BEFORE THE OTAGO REGIONAL COUNCIL

In the matter of application **RM19.151** by **BSTGT Limited and Trustees of the A P McQuilkin Family Trust** for a permit to take and use water

STATEMENT OF EVIDENCE OF BAS VEENDRICK

11 MAY 2021

FIGURE 1 : KEY LOCATIONS AND GAUGED FLOWS FOR THE ROYAL BURN 22 FEBRUARY 2021

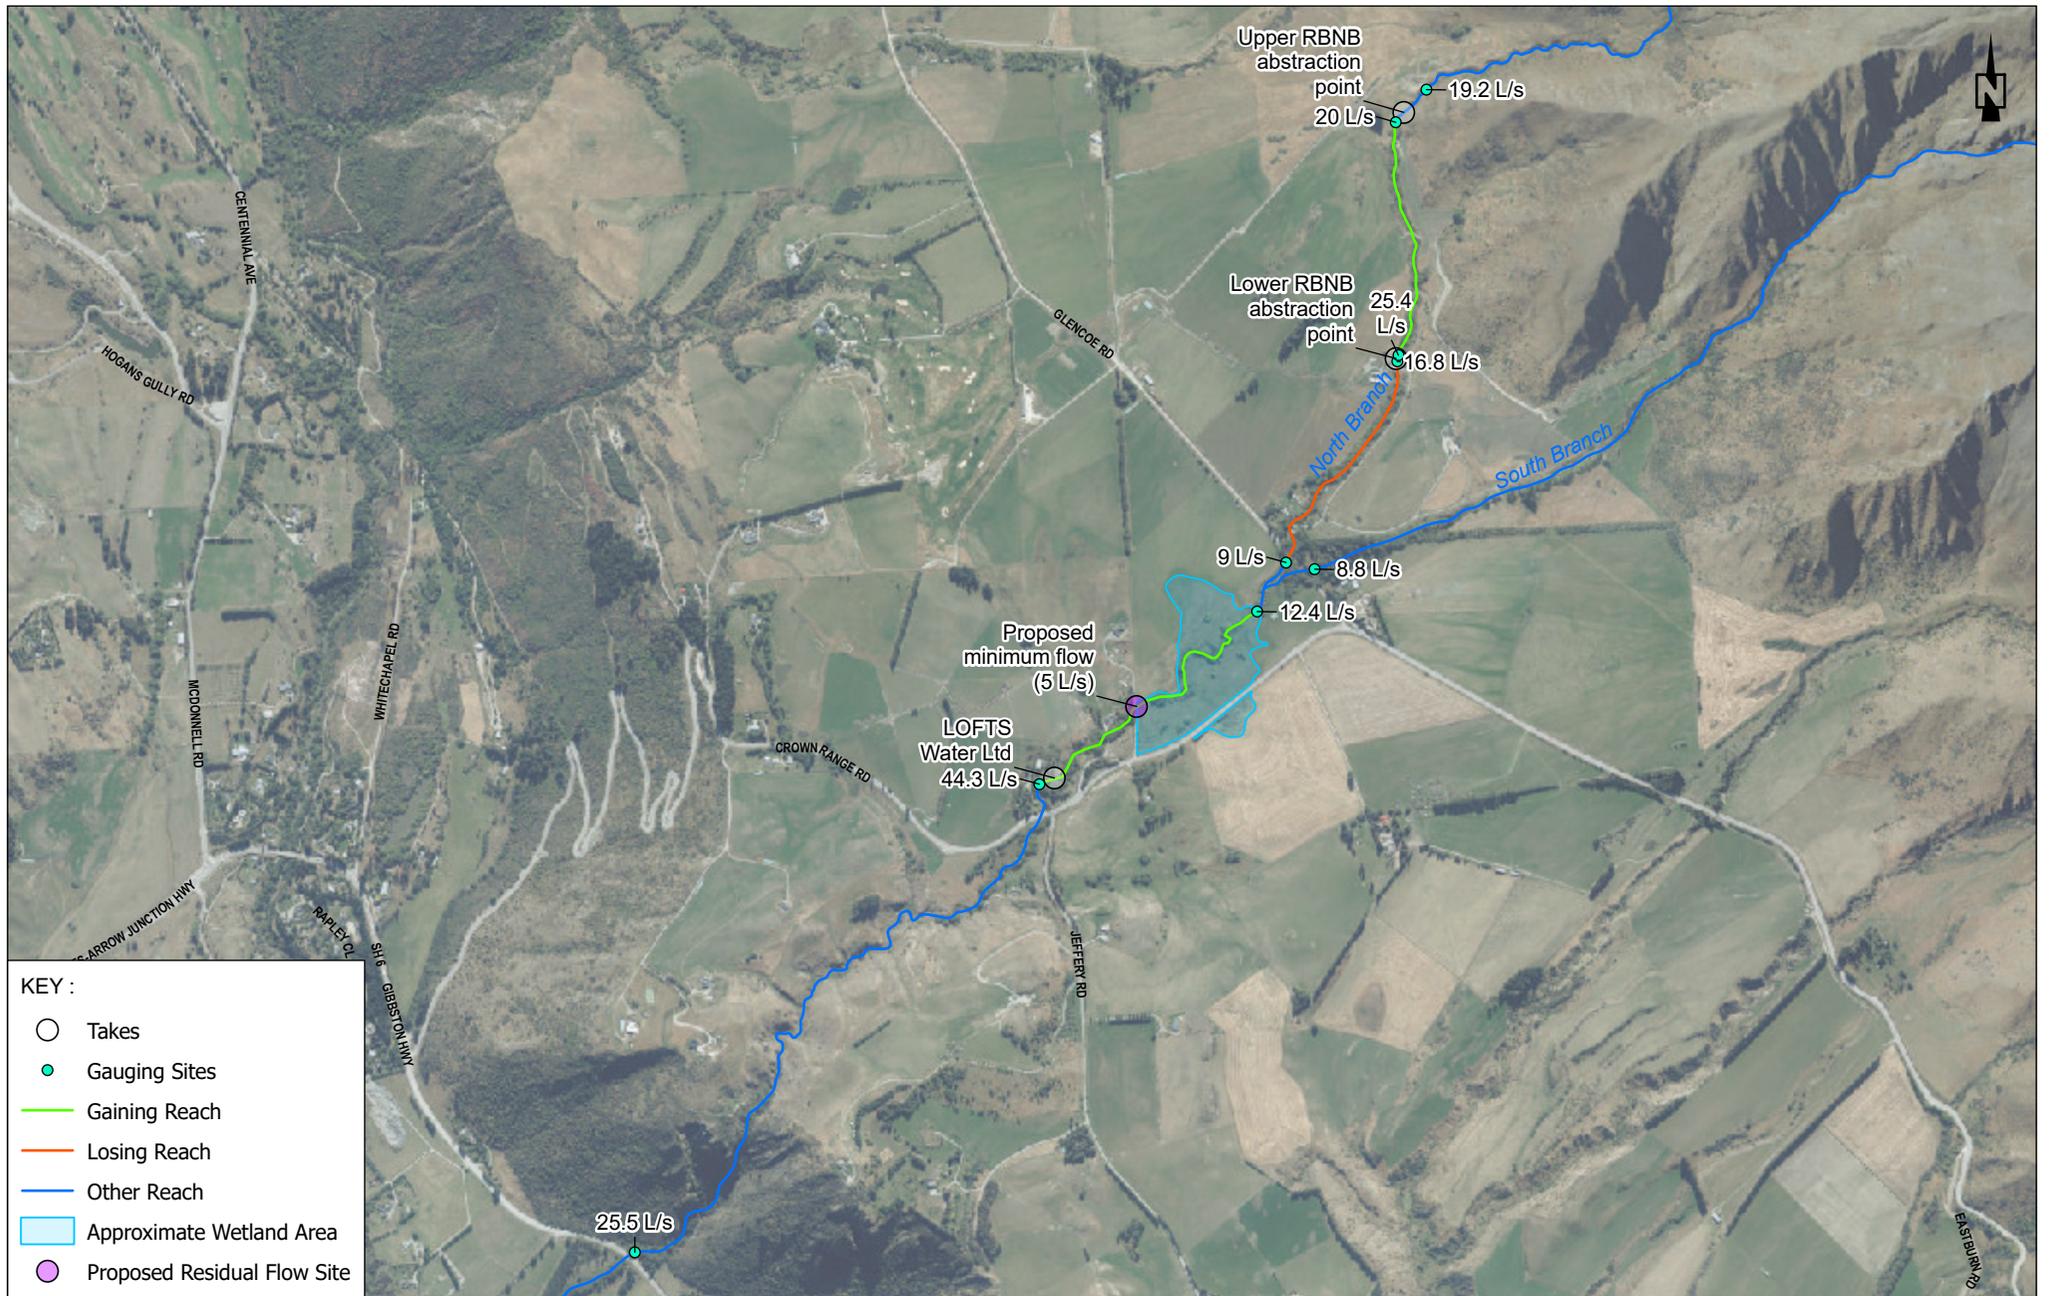
29. NIWA were engaged by the applicant to undertake a longitudinal flow gauging assessment of the Royal Burn catchment. NIWA measured the flows at nine key locations along the Royal Burn on 22 February 2021. Figure 1, attached to my evidence show the gauging results. On the basis of this information, the applicant concludes that the Royal Burn North Branch experiences losses to ground between the lower point of take and the swamp (shown as approximate wetland area on Figure 1). The applicant further concludes that there are gains (to the flow in the Royal Burn) between the swamp and the Crown Range Road crossing. I concur with the applicants' conclusions in this regard although note that this pattern is expected to vary based on surface flows and groundwater levels.

38. It is unclear how the figure of 13.2 L/s is derived. The longitudinal gauging study appears to indicate that losses to ground on the Royal Burn North Branch between the lower intake and Glencoe Road were 7.8 L/s on that day. This is derived by subtracting the gauged flow beneath the Glencoe Road Culvert (9.0 L/s) from the flow gauged below the lower abstraction point (16.8 L/s) (refer to Figure 1 attached to my evidence).

39. The NIWA longitudinal gauging run indicates a gain of around 5 L/s between the upper and lower intake. However, observations from the applicant in early 2018 indicate that at times of low flow (and/or groundwater levels) this reach of the waterway may experience losses rather than gains. The application states:

40. In summary it is unknown what the loss rate is at flows greater or less than those measured during the longitudinal gauging run. If groundwater levels are significantly below the invert level (bottom) of the stream, then losses will be determined by the wetted width and hydraulic head in the stream. Both will decrease as flow decreases and therefore losses to ground would also be expected to decrease. If the stream is directly connected to groundwater, then the relationship will be dependent on groundwater levels relative to the water level in the stream.
